ON Semiconductor

FINAL PRODUCT/PROCESS CHANGE NOTIFICATION
Generic Copy

SUBJECT: ON Semiconductor Final Product/Process Change Notification #16164

TITLE: Addition of PLCC20 / 28 package assembly capabilities at Amkor Technology Philippines (P1) Inc. package assembly site

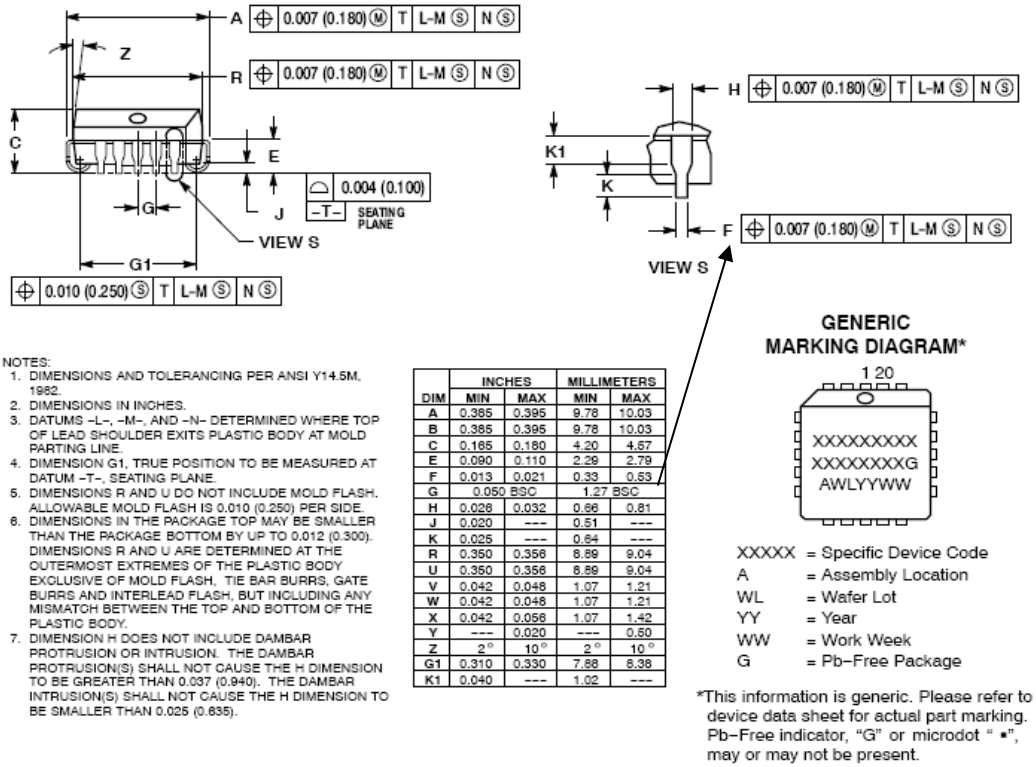
There is a minor dimension change related to the package lead width (see table below). ON Semiconductor has completed the update of the package drawing for this one change.

BEFORE	ON SEMI POD					AMKOR POD (00060/14)			REMARKS
	SYMBOL	MIN	NOM	MAX	SYMBOL	MIN	NOM	MAX	
leadwidth (external)	F	0.013	-	0.019	-	0.013	-	0.021	not compliant with current dimensions for max specs
AFTER	**ON SEMI POD**					**AMKOR POD (00060/14)**			**REMARKS**
	SYMBOL	MIN	NOM	MAX	SYMBOL	MIN	NOM	MAX	
leadwidth (external)	F	0.013	-	0.021	-	0.013	-	0.021	now compliant with current dimensions for max specs
